S E R V I C E B U L L E T I N

Fuji Heavy Industries, Ltd.

NO. FAS-025

1. SUBJECT : To burr the canopy rail.
2. AIRCRAFT AFFECTED : FA-200 Serial No. 1 through 86 airplanes.
3. PRIORITY : Desirable.
4. REASON : The rails are burred and chamfered to prevent hand's injury for the canopy top rail.
5. DESCRIPTION : Chamfer the exposed portion (especially front area) of the canopy top rail with proper file and make the smooth radius as far as possible. Finish the surface with some sand papers.

Section of, Canopy Ceiling Rail

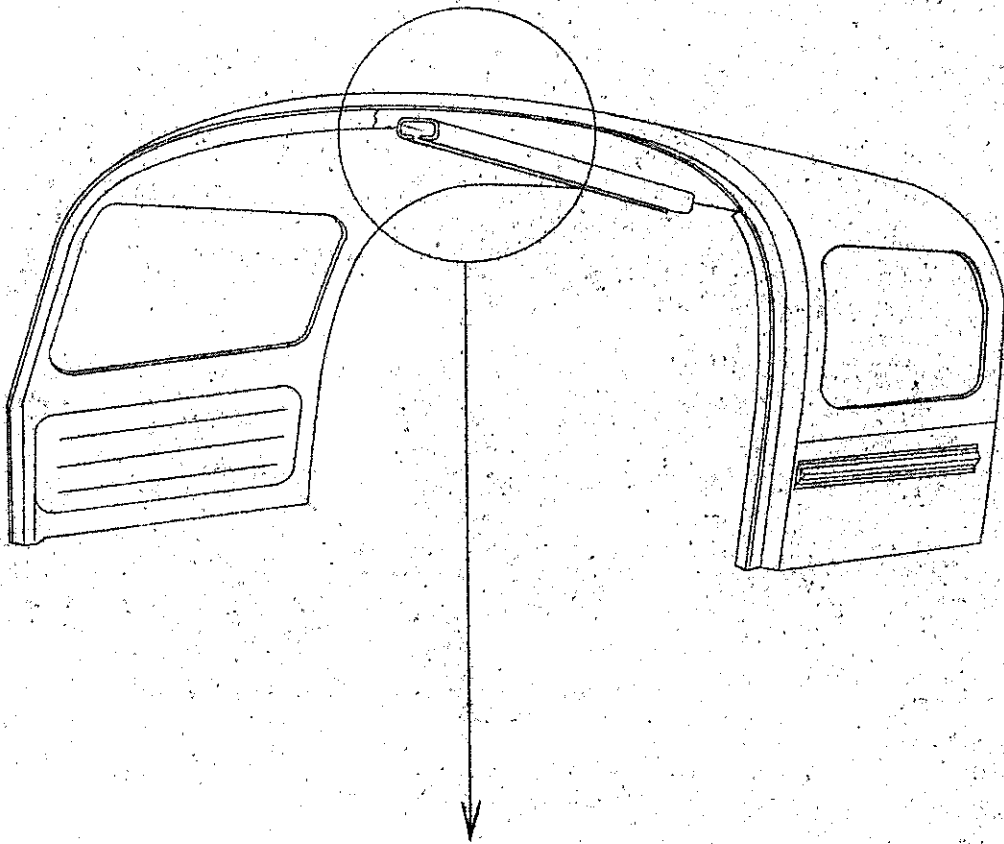
Remove All Burrs
and Sharp Edges.
